RE: Response to Comments – Fifth Submission Review
The Aurora Highlands North – Area A – Site Plan
Application Number: DA-2062-31
Case Numbers: 2022-4027-00

THE AURORA HIGHLANDS AREA A
SITE PLAN EXHIBIT
MARCH 2024

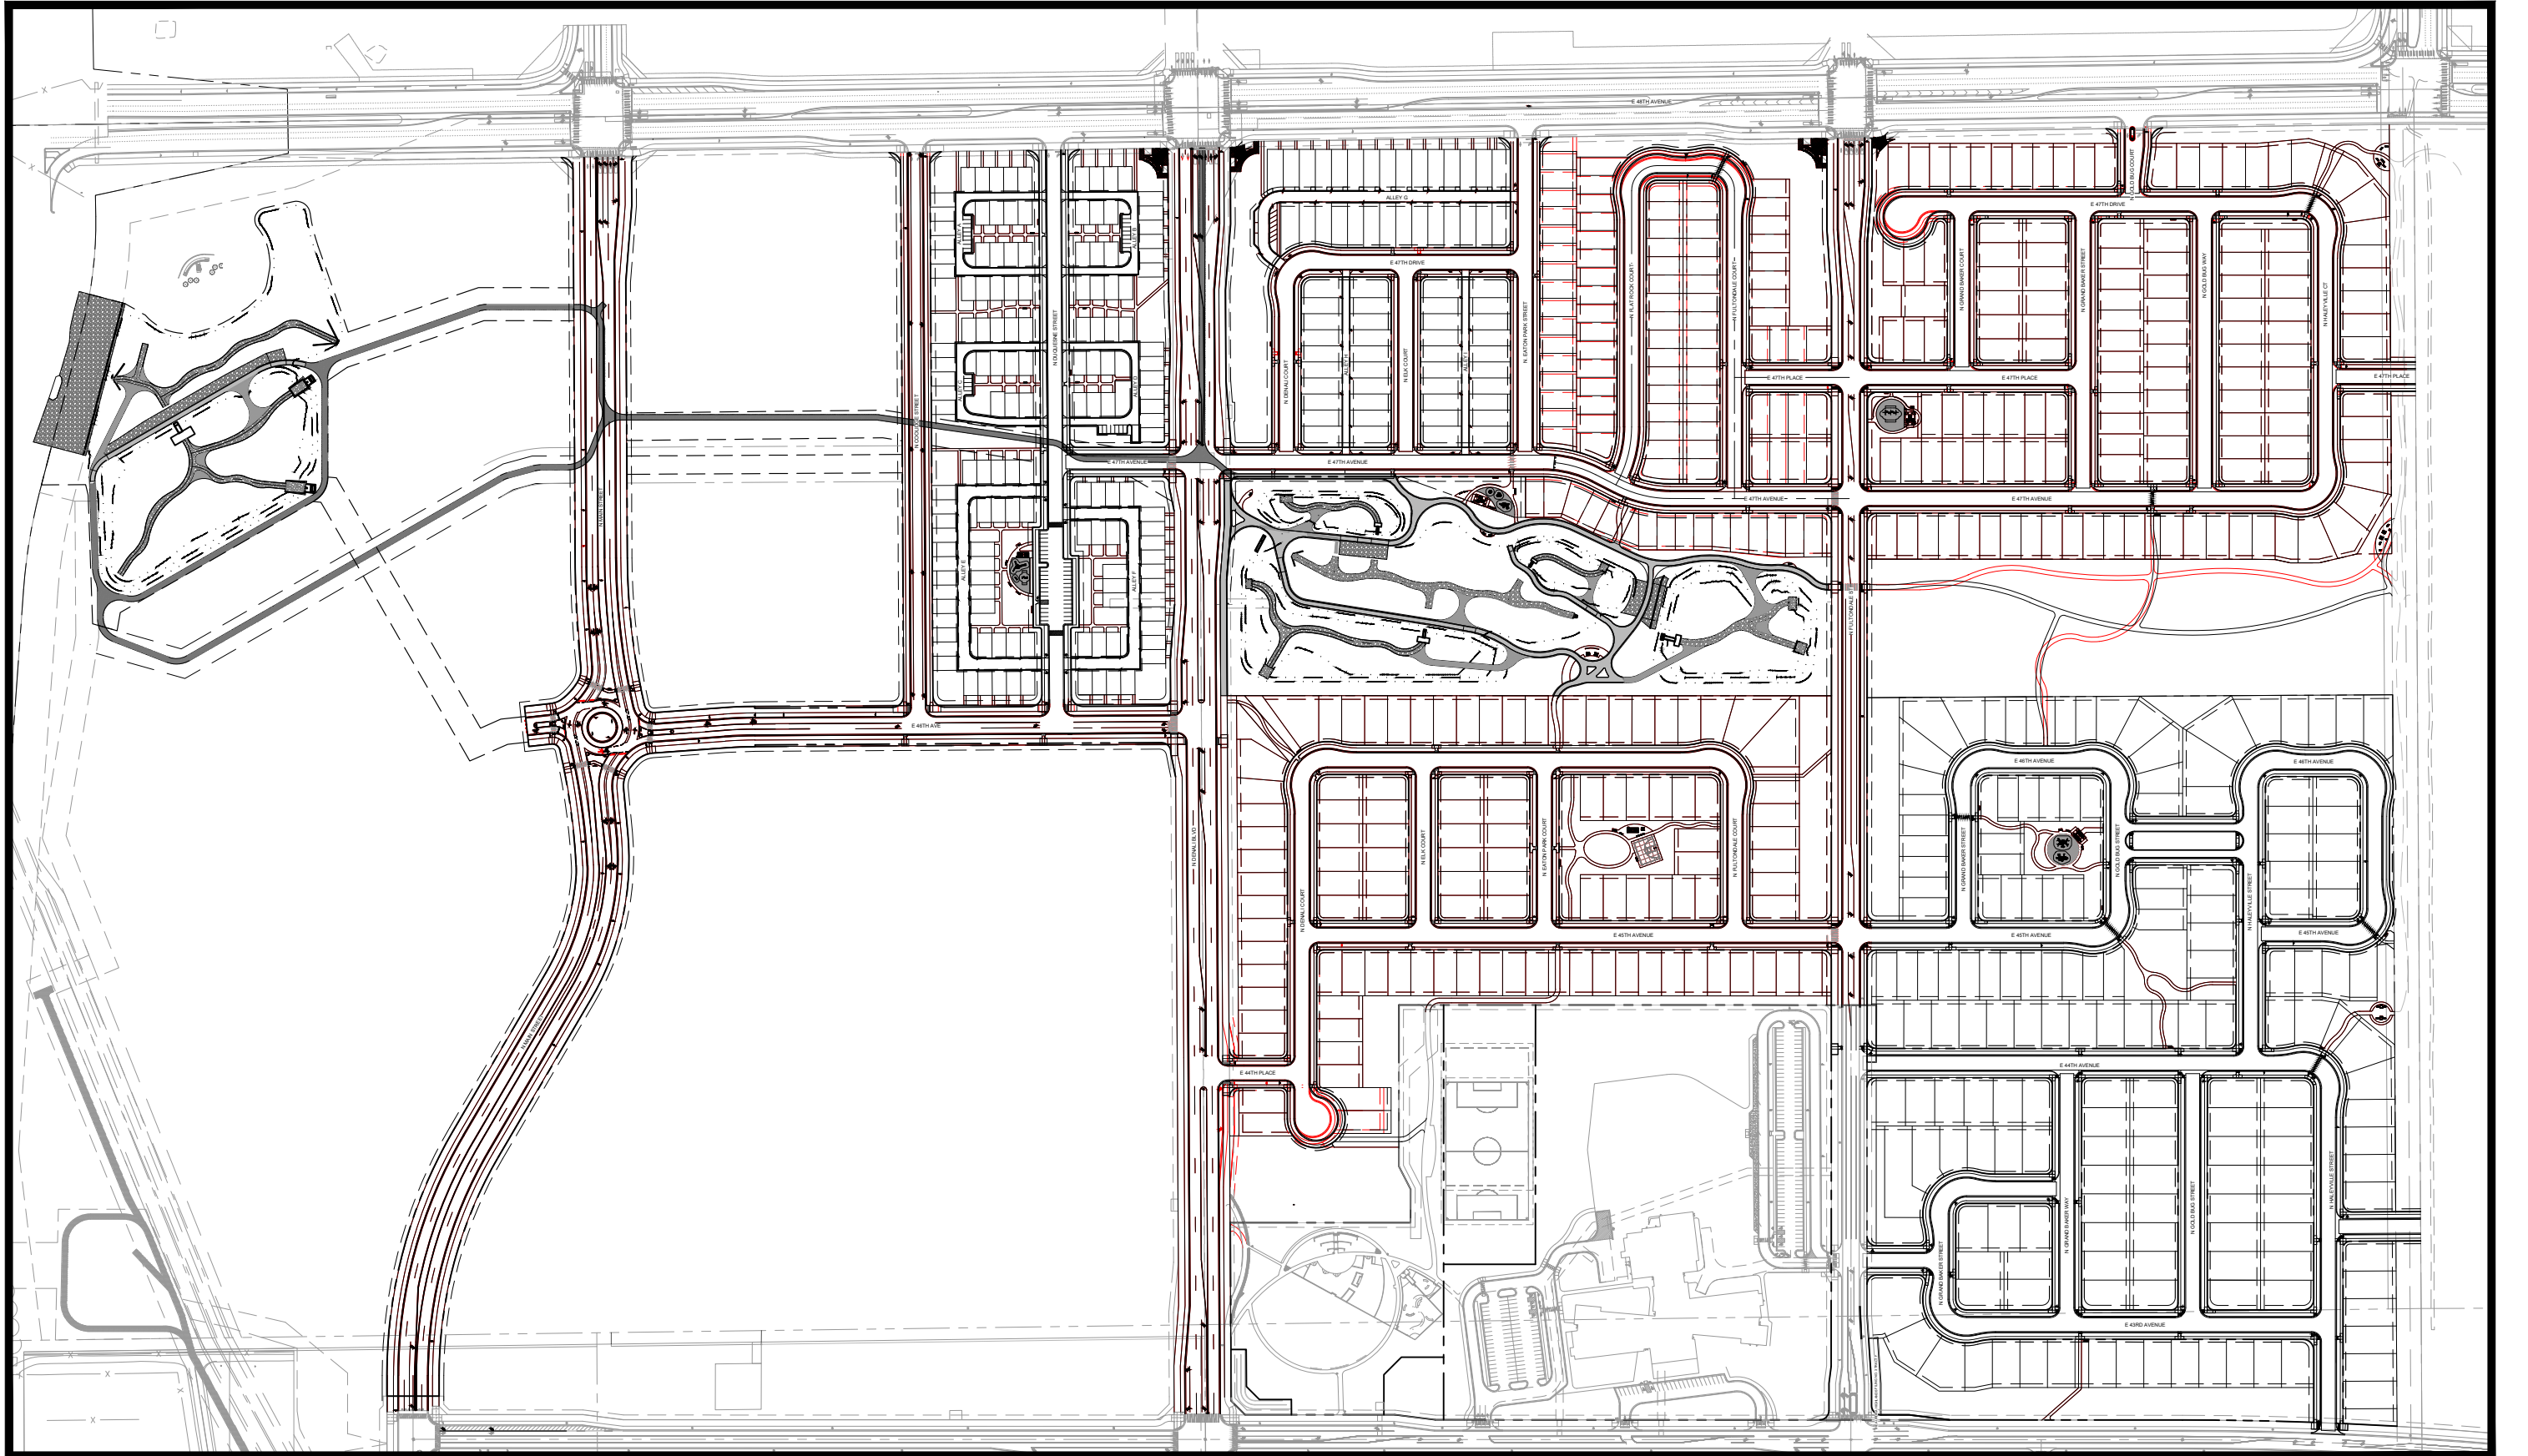
Below are a summary of the city comments and our responses below the comment in bold. There were some layout revisions since the previous submittal. An exhibit is attached to the end of this letter as well as was emailed to you. The cul-de-sac radii in PA6 and PA12 were increased. The decel and accel lane into PA6 were removed. This was coordinated with Carl. The east west road in PA5.2 was shifted north to help with the lot layout.

1A. Several revisions have been made to the plans since the last review. Any changes, especially those not requested by staff, should be identified in the cover letter attached to the response to comments. Unexpected changes may result in additional reviews to get clarification.

Response: An exhibit has been put together overlaying the site plan from the November submittal and the current submittal. The red line work is from the November submittal and the black line work is the current site plan.
